ANN ARBOR HISTORIC DISTRICT COMMISSION

Staff Report

ADDRESS: 213 South Main Street, Application Number HDC15-155

REPORT DATE: September 10, 2015

ENLARGED STOREFRONT ELEVATION

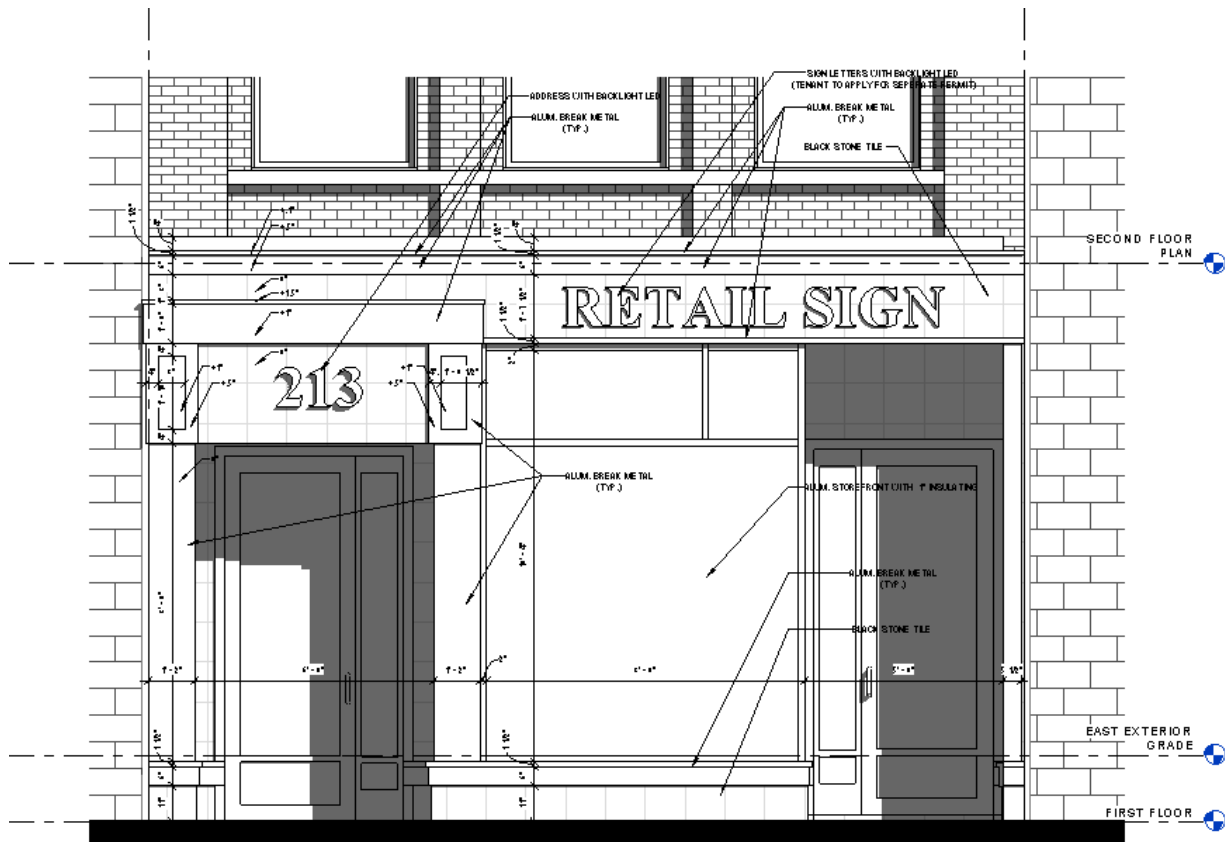
3. One of the storefront drawings indicates backlit signage, which is not appropriate. Otherwise, the size and location of the conceptual retail sign is appropriate. A separate staff approval (for non-backlit signage) will be required before a sign permit may be issued for the new tenant.

East Elevation

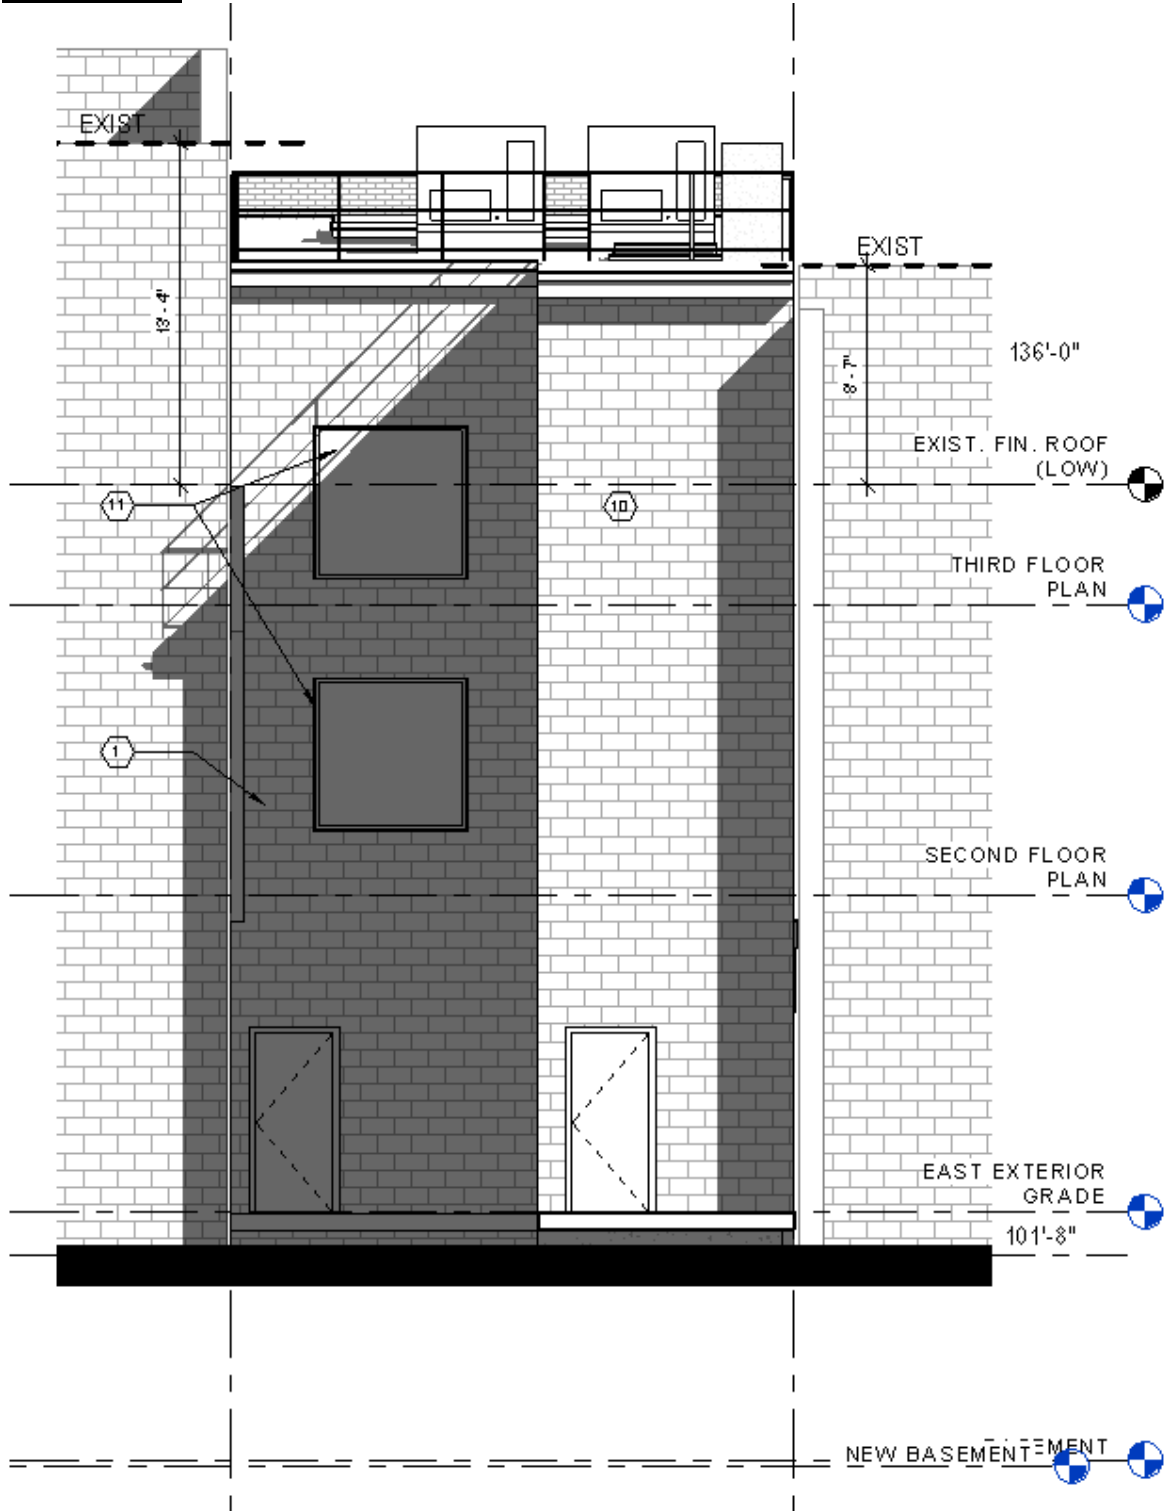
5. The remainder of the rear wall of the building is proposed to be rebuilt at the same time the stair tower is constructed. A letter from the project engineer says this is for improved aesthetics, rather than structural reasons, but staff believes the wall and its openings have been altered and its historic integrity compromised over the years. Since photos of the existing conditions were not included as part of the application, the Review Committee visit will verify the extent of the changes to the rear wall, and its visibility from the alley that runs behind the building.
